**Calvert Cliffs
Nuclear Power Plant**

SUBJECT: Calvert Cliffs Nuclear Power Plant
Unit Nos. 1 & 2; Docket Nos. 50-317 & 50-318
Response to Request for Additional Information Concerning the Containment
Tendon Long-Term Corrective Action Plan (TAC Nos. MA7782 and MA7783)

**RESPONSE TO REQUEST FOR ADDITIONAL INFORMATION CONCERNING
THE CONTAINMENT TENDON LONG-TERM CORRECTIVE ACTION PLAN**

**Extended Model for Containment
Building Vertical Tendon
Degradation for
Calvert Cliffs 1 and 2**

Figure 1

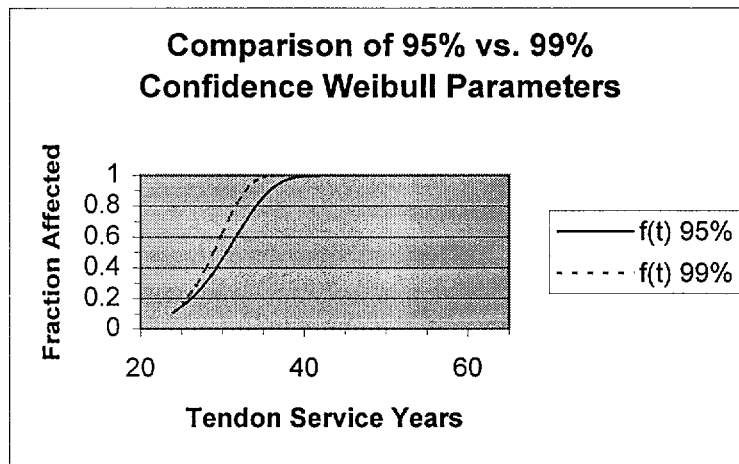
There is uncertainty in both parts of the statistical model. The first part of the model is the Weibull model for number of tendons affected. The parameters b and θ were determined from the plot of the two inspection data points (Figure IV-2 in Enclosure 1). Since the 1999 inspection data point was determined from a sample, there is uncertainty in the actual number of additional tendons affected by broken wires in 1999. This uncertainty was accounted for by constructing a 95% confidence interval for the number of tendons affected in the entire tendon population. The 95% confidence upper bound for number of tendons affected was used to plot the slope labeled 95% confidence in the figure. For comparison a 90% confidence interval and 50% confidence interval were also constructed. One can see that from the 50% slope to the 90% slope there is a large change. However, the change from the 90% slope to the 95% slope is much smaller, indicating diminishing returns as one goes to higher confidence levels. Therefore, the uncertainties in the determination of b and θ from the actual inspection data have been conservatively accounted for.

However, if a 99% confidence interval had been used instead of a 95% confidence interval, the 1999 inspection data point would become 51 affected tendons. The resulting Weibull parameters for the 99% confidence slope are $\theta = 30$ years and $b = 9.5$. Figure 1 is a plot of the Weibull function using both the 95% parameters ($\theta = 32$, $b = 7.5$) and the 99% parameters ($\theta = 30$, $b = 9.5$). The figure shows the fraction of affected tendons reaches almost 100% relatively quickly. For the 99% parameters, the 100% affected level is reached in about 2008 versus 2014 for the 95% parameters. In the short term, the number of affected tendons is slightly higher. However, the ultimate number of broken wires at the end of plant life is insensitive to the choice of the 95% or 99% confidence Weibull parameters.

Figure 2

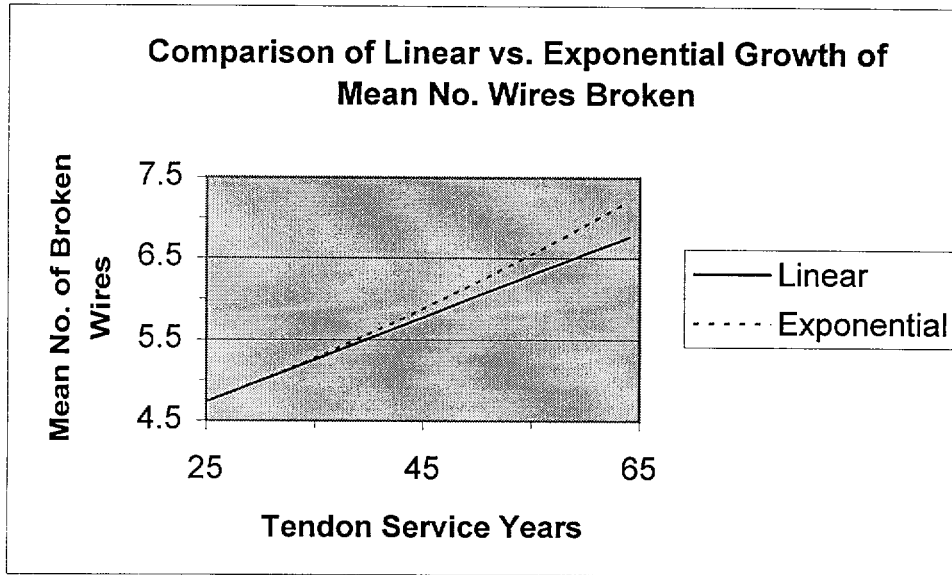
6. *Provide a copy of the BGE engineering report mentioned during the above noted telephone conference which addresses BGE's development of its containment tendon Weibull models and, as appropriate, discuss in detail how uncertainties related to the models were adequately dealt with (e.g., performance of sensitivity analysis).*

Figure 2 shows a plot of m calculated using both the linear and exponential methods. The difference in the predicted mean number of wires broken using both methods is minor. In the short-term, both methods predict a virtually identical number of broken wires, while at the end of plant life, the exponential method predicts a slightly greater number of wires broken. Table 2 compares the values obtained at several different points in time using both methods. The ultimate number of wires predicted to be broken at the end of plant life using the exponential method is 1471, compared to 1380 for the linear method that was actually used.
